PRELIMINARY PLAN FALCON MARKETPLACE

PRELIMINARY PLAN FOR
FALCON
MARKETPLACE
FALCON, COLORADO

ISSUE	DATE
EXHIBIT	1-17-17
2nd SUBMITTAL	3-23-17
3rd SUBMITTAL	5-19-17
4th SUBMITTAL	6-18-18

COVER SHEET

PP-2

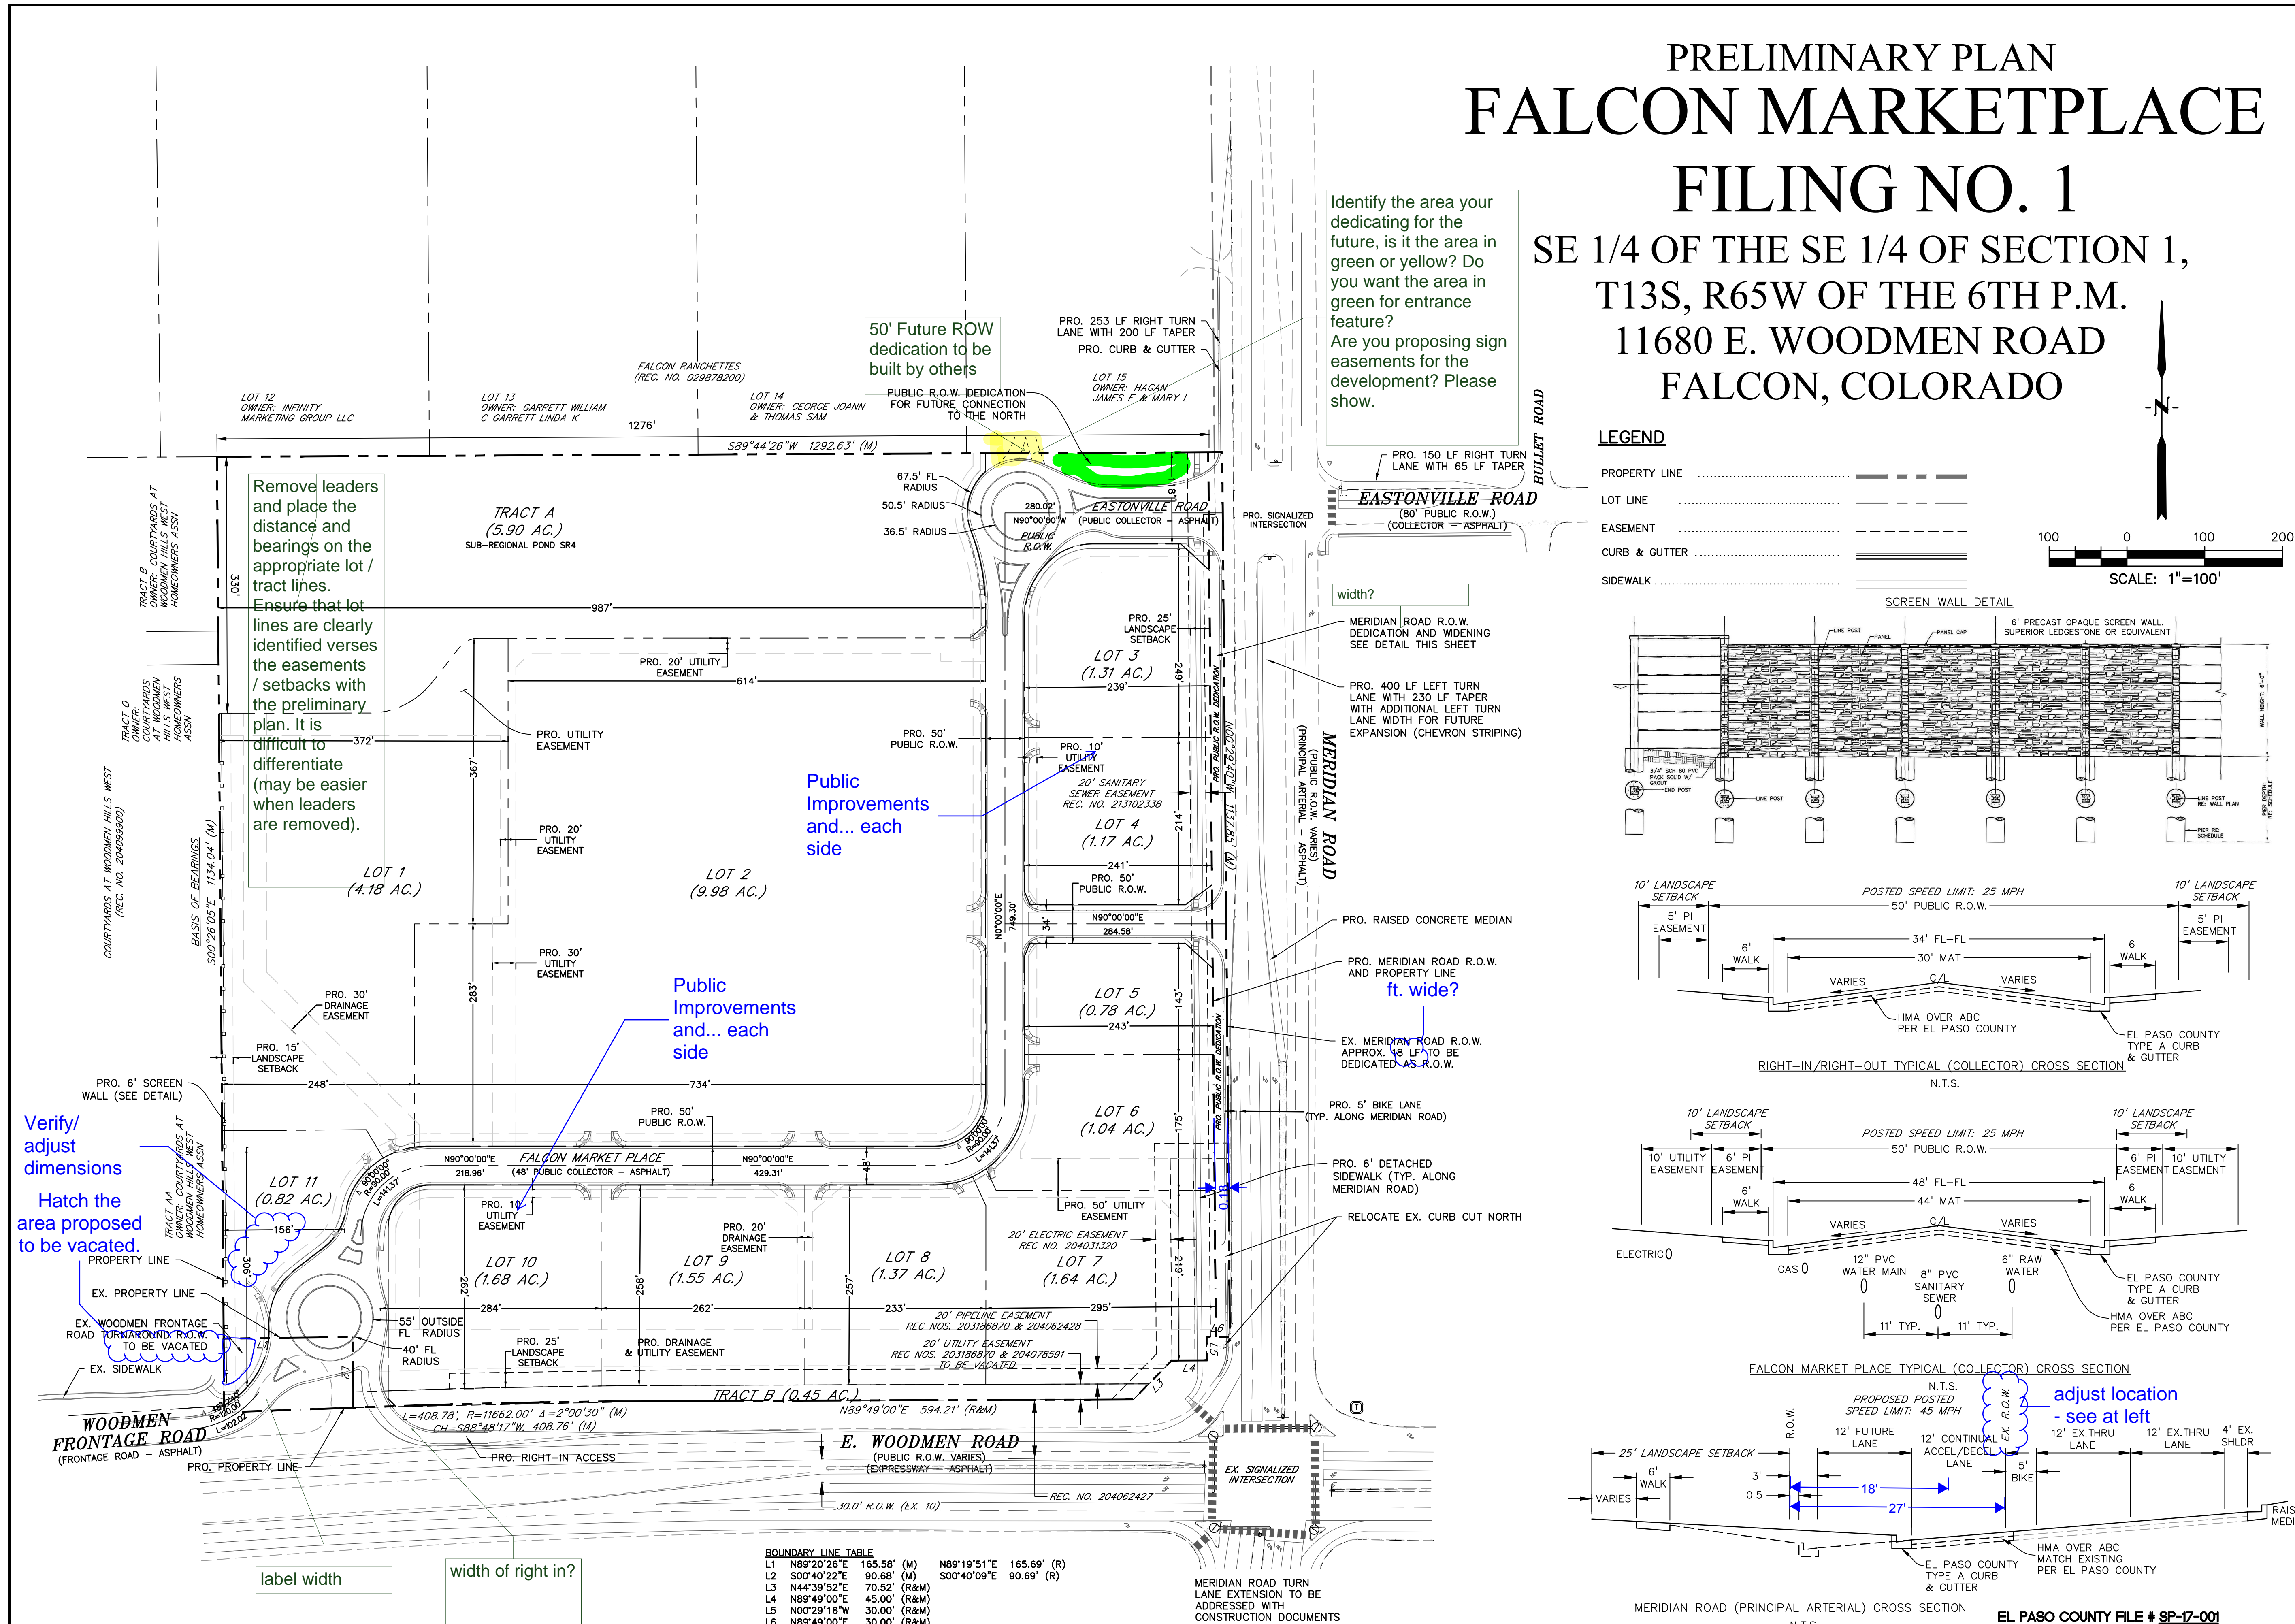
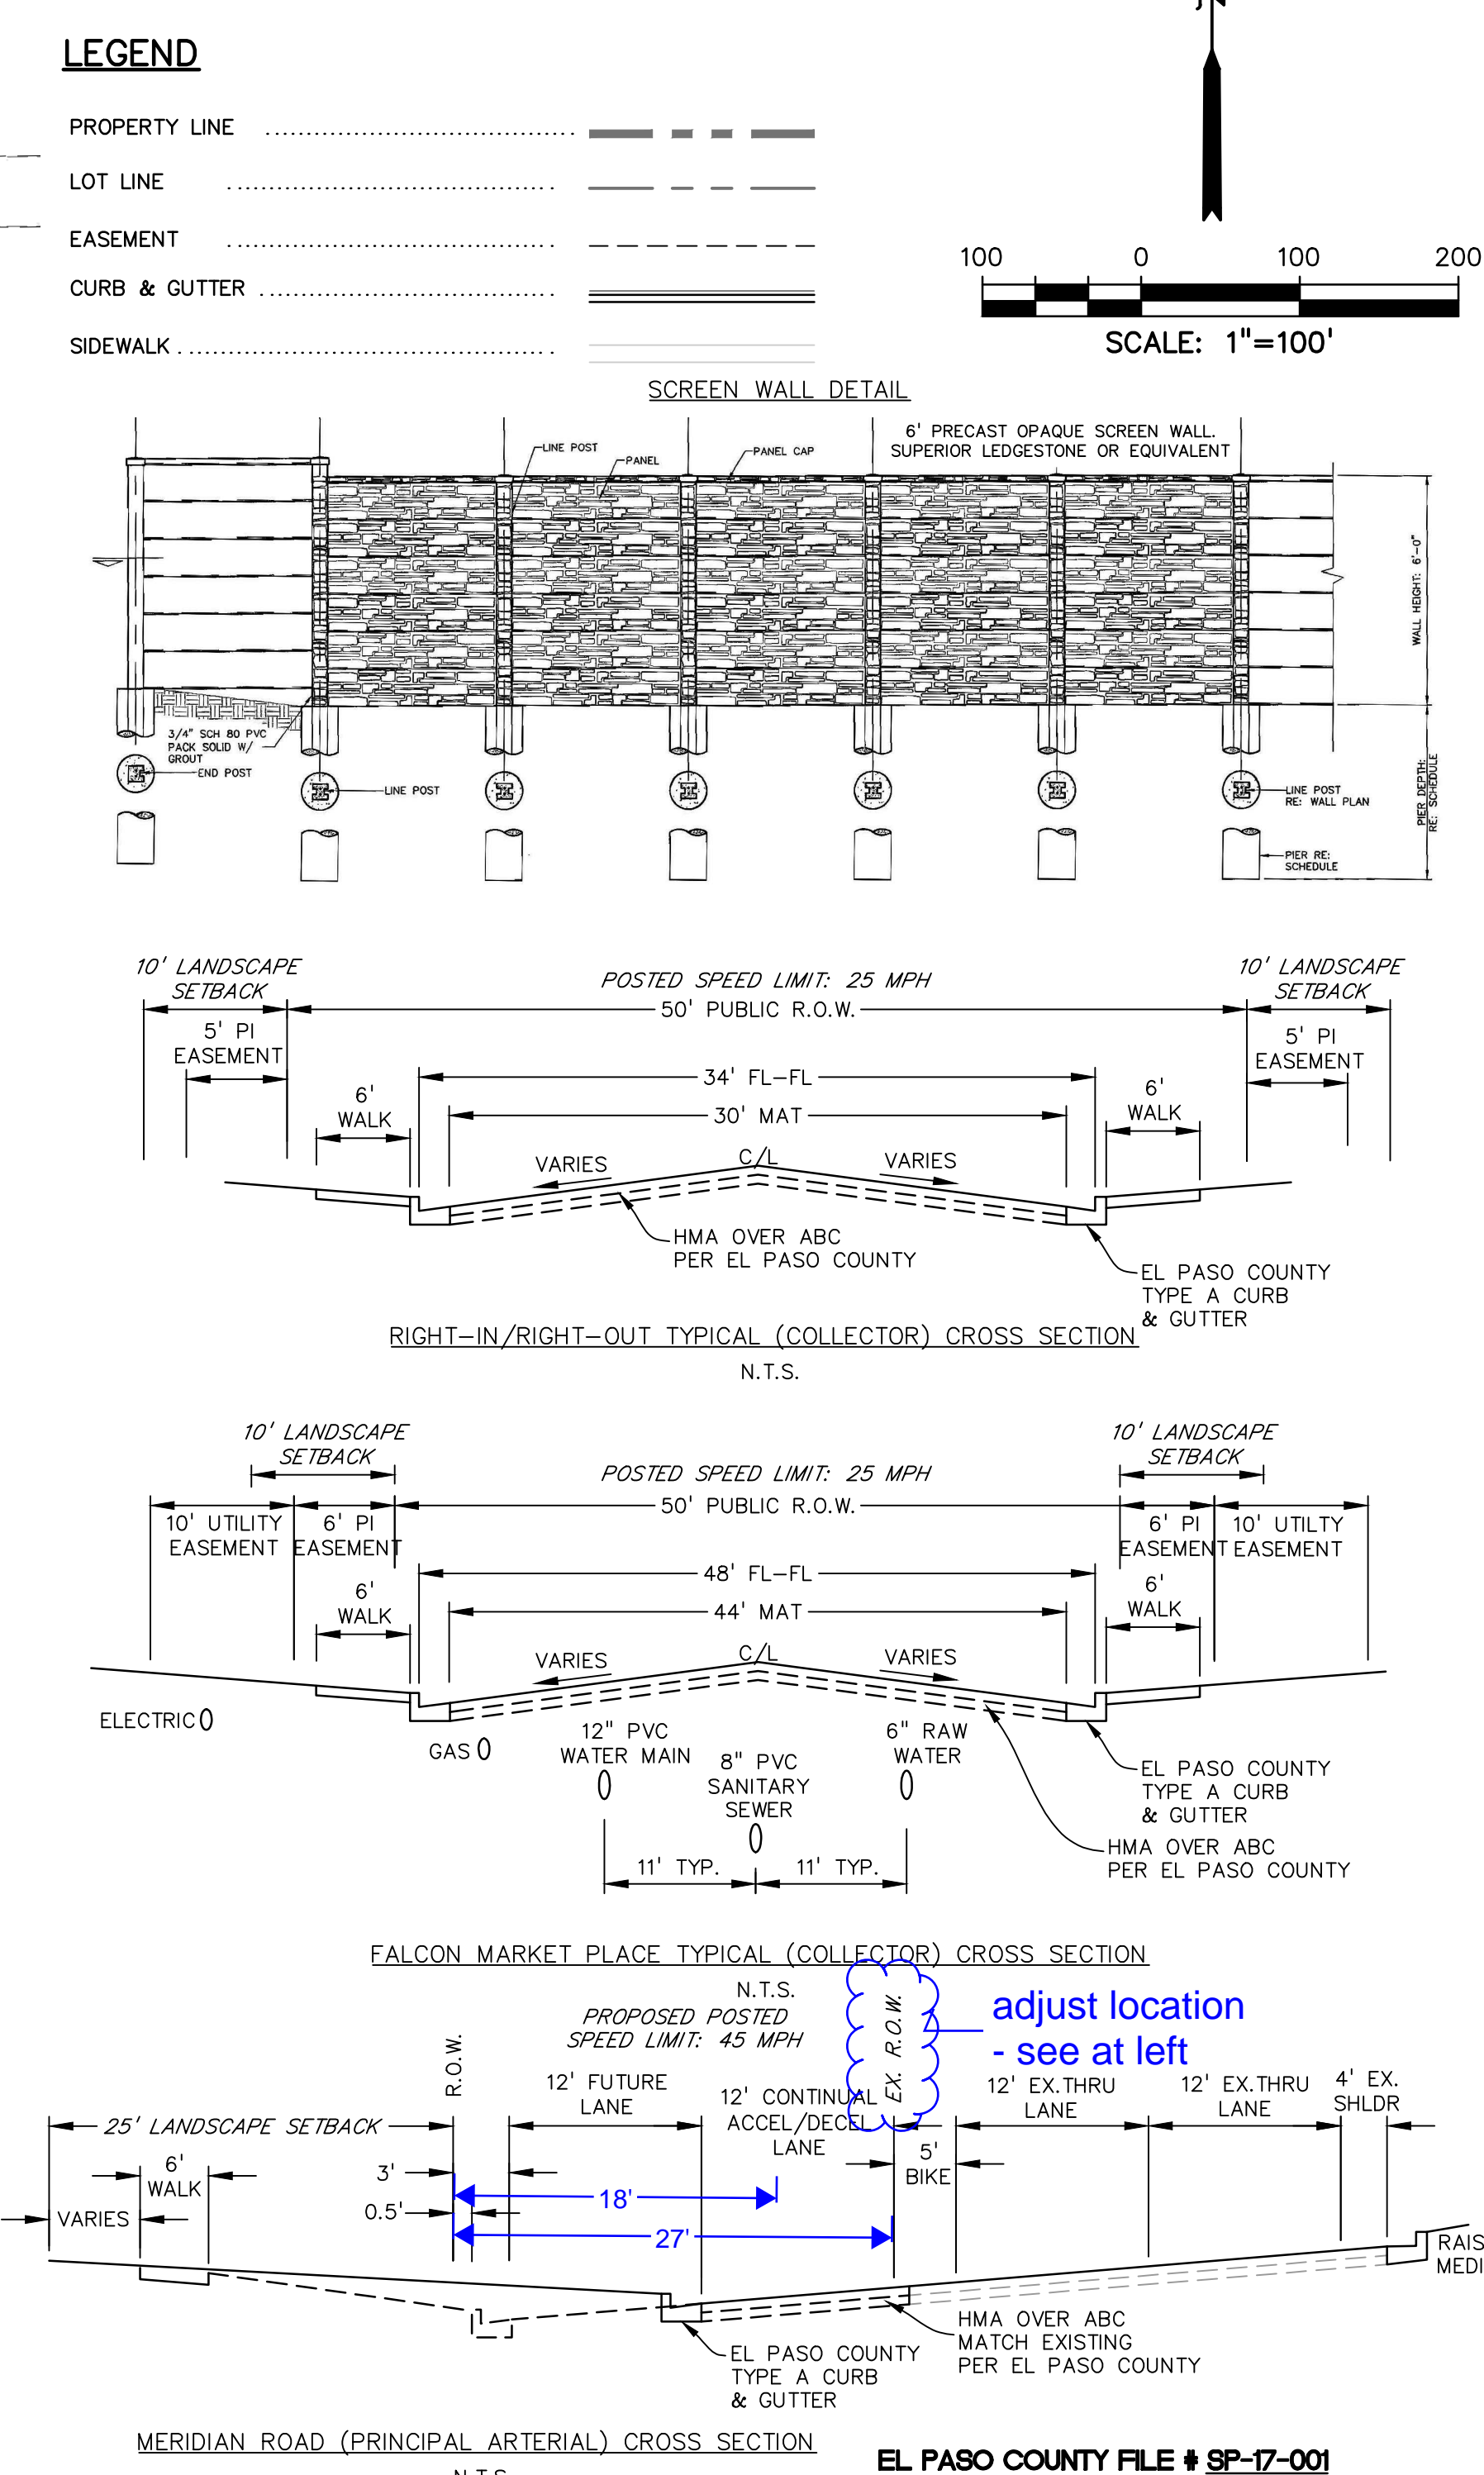
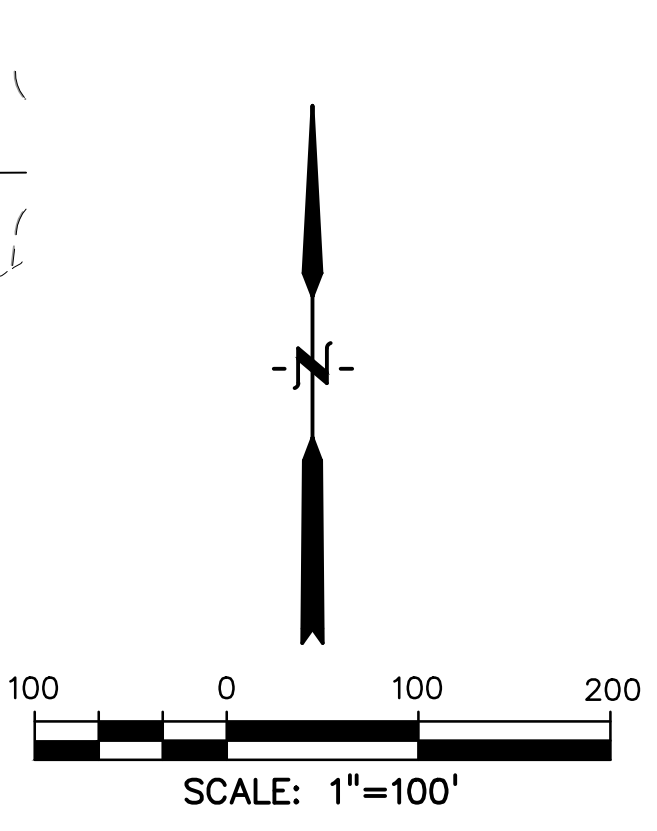
Identify the area your dedicating for the future, is it the area in green or yellow? Do you want the area in green for entrance feature? Are you proposing sign easements for the development? Please show.

Remove leaders and place the distance and bearings on the appropriate lot / tract lines. Ensure that lot lines are clearly identified verses the easements / setbacks with the preliminary plan. It is difficult to differentiate (may be easier when leaders are removed).

Verify/ adjust dimensions
Hatch the area proposed to be vacated.

label width

width of right in?

width?

ft. wide?
